Amendment to Approved Plan.
16/62/92245.

Proposed detached garage.

@ 8 Hazel Grove, Fixby, HD2 2JP.
for Mr H. Rashid.

16/042/G2

Plan.

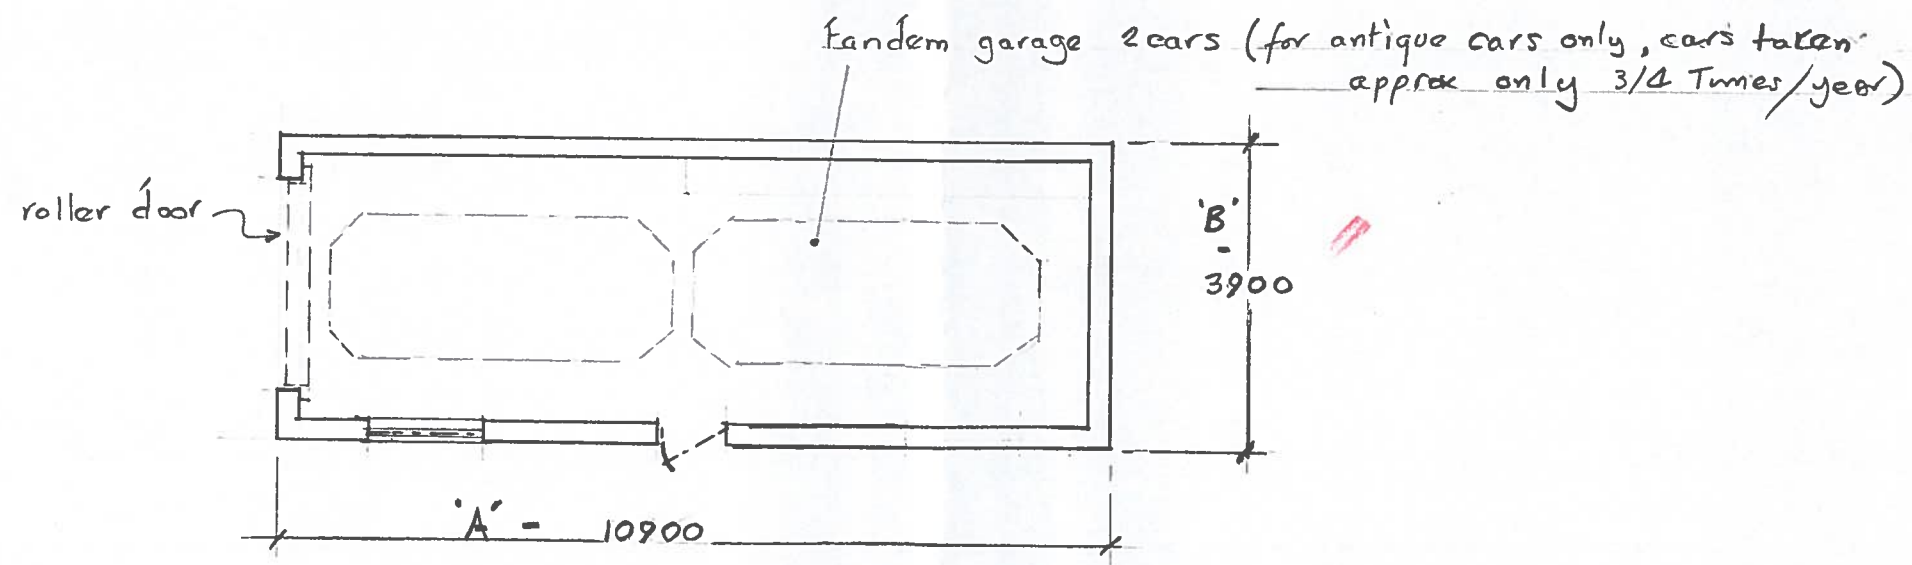
'A' dimension increased from 10.2 to 10.9
'B' " " " 3.6 to 3.9

• reason client needs a little more room around his two classic antique cars
